Access Compliance Report

Public Rights-of-Way (Curb Ramps)

Intersection ID: 16048	Main Street: OXFORD_PL	Cross Street: PROVIDENCE_RD	Location: NW
ADA ID: B962ED80E45B	Ramp Type: PerpDiag	Initial Pass/Fail: Fail	Overall Compliance: No
Codes/Mitigation Info/Possible Solution		Field Measurements/Component Compliance	
Severity Score: 25

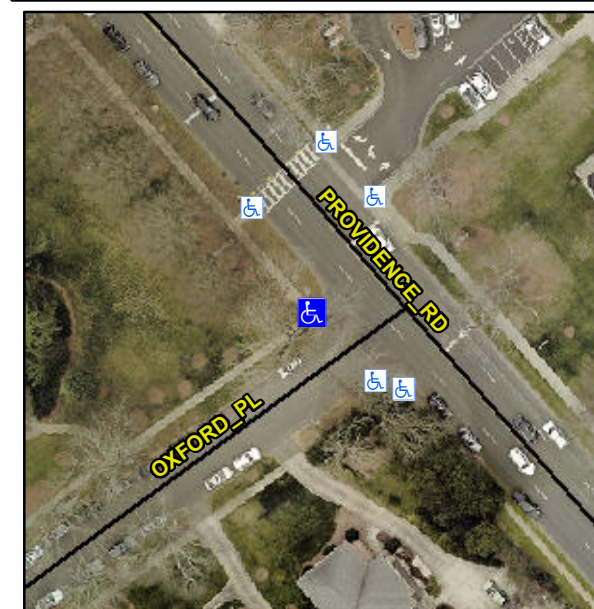
R304.2.2

Compliance	Description	Data	Compliance	Description	Data
N/A	Ramp Length (in)	82.0	No	Ramp Slope (%)	14.9
Yes	Ramp Width (in)	48.0	Yes	Ramp XSlope (%)	1.8
N/A	Flare Type LT	N/A	N/A	Flare Type RT	N/A
N/A	Flare Slope LT (%)	N/A	N/A	Flare Slope RT (%)	N/A
N/A	Flare Traversable LT?	N/A	N/A	Flare Traversable RT?	N/A
N/A	Landing Length (in)	N/A	N/A	DWS Provided?	N/A
N/A	Landing Width (in)	N/A	N/A	DWS Contrast?	N/A
N/A	Landing Slope (%)	N/A	N/A	DWS Length (in)	N/A
N/A	Landing X Slope (%)	N/A	N/A	DWS Full Width?	N/A
N/A	Landing Curb? (Y/N)	N/A	N/A	DWS Offset (in)	N/A
N/A	Shared Landing?	N/A			
N/A	Gutter Ponding?	N/A	N/A	Gutter Slope (%)	N/A
N/A	Gutter Lip Ht (in)	N/A	N/A	Gutter X Slope (%)	N/A
N/A	Painted X Walk1?	No	N/A	Painted X Walk2?	No
	X Walk 1 Direction	To SE		X Walk 2 Direction	To NE
N/A	X Walk 1 Width (in)	N/A	N/A	X Walk 2 Width (in)	N/A
	X Walk 1 Slope (%)	2.0		X Walk 2 Slope (%)	1.8
	X Walk 1 X Slope (%)	0.9		X Walk 2 X Slope (%)	1.5

Remove & Replace Curb Ramp With Two New Directional Ramps or Equivalent.
